**LAFAYETTE HEIGHTS SUBDIVISION,**  
**RESUBDIVISION OF LOT 4 AND A PORTION OF**  
**LOT 3, BLOCK 2**

APPLICATION NUMBER 6 DATE November 19, 2009

REQUEST Subdivision

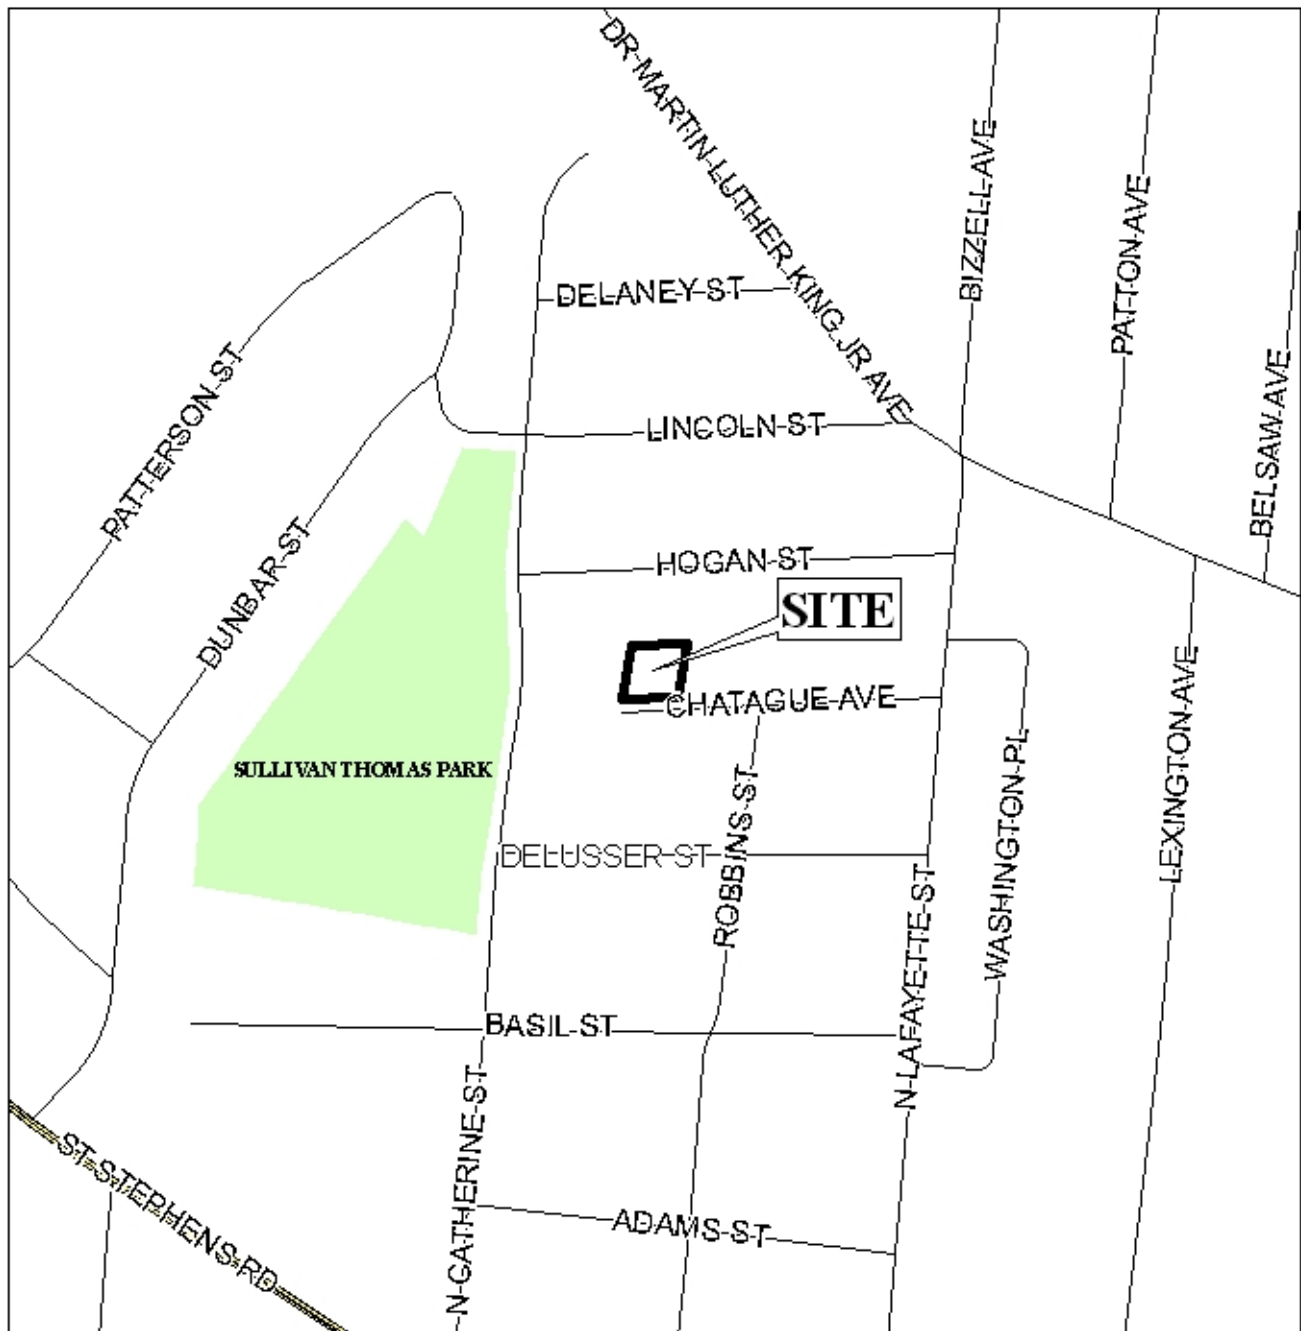
The proposed subdivision is located between Chatague Avenue and what is labeled as Bert Street on the plat, but which is actually an unnamed and unopened standard 20' alley. Chatague Avenue is indicated with a non-compliant 30' right-of-way and dedication to provide 25' from centerline would normally be required. However, since the site is at the dead end of Chatague Avenue and a similar subdivision was approved in 2006 within the same block approximately 270' East of the site without dedication, it would stand that dedication should not be required in this instance and Section VII.A.1. of the Subdivision Regulations should be waived. The 25'

building setback line should also be measured from the existing right-of-way line as was approved in that previous subdivision.

As a means of access management, a note should be required on the final plat stating that the lot is limited to one curb cut to Chatague Avenue, with the size, location, and design to be approved by Traffic Engineering and conform to AASHTO standards. Also, a note should be required on the final plat stating that access to the unopened, unnamed alley to the rear is denied until such time that it is developed to standards. The lot should be labeled on the final plat with its size in square feet and acres, or a table should be furnished on the final plat providing the same information.

- 1) illustration of a 25' minimum building setback line as measured from the existing right-of-way line along Chatague Avenue;
- 2) placement of a note on the final plat stating that the lot is limited to one curb cut to Chatague Avenue, with the size, location, and design to be approved by Traffic Engineering and conform to AASHTO standards;

- 3) placement of a note on the final plat stating that the lot is denied direct access to the unnamed, unopened alley to the rear until such time it is developed to standards;

- 4) labeling of the lot on the final plat with its size in square feet, or the furnishing of a table on the plat providing the same information;
- 5) placement of a note on the final plat stating that development of this site must be undertaken in compliance with all local, state and Federal regulations regarding endangered, threatened or otherwise protected species; and
